Service Bulletin – Install RIG tag on Polar Brand Semi-Trailer

Instruction for installing the certification tag on the Rear Impact Guard (RIG) in accordance with Polar NHTSA Recall #23V585.

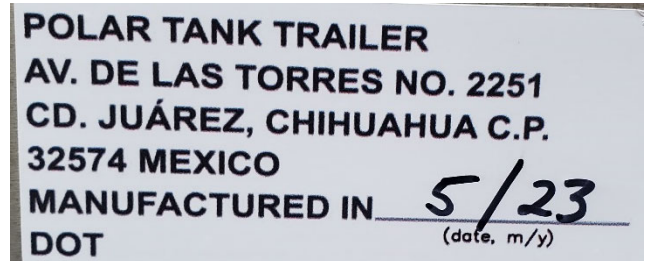
- 1) Tag will be installed on the passenger side of the RIG, on the *forward* side.

- 2) Self-Adhesive tag is to be applied approximately 10" from the edge of the tube as shown. Clean the dirt and grease from the tube before applying the tag using isopropyl alcohol, or similar cleaner.
- 3) Important: The manufacturing date must be written on the tag in permanent marker as shown above. The date to be used is the same as the trailer manufacturing date listed on the trailer data plate, which is on the drivers side near the support legs.
- 4) Once the installation is complete, notify Peter Weis at Polar Tank Trailer. Since this is a Federal Recall, we will be following up to assure that the tag has been installed. Contact information:
 - a. E-mail pweis@entransinternational.com, or
 - b. Phone 320 746 3471 (leave message)
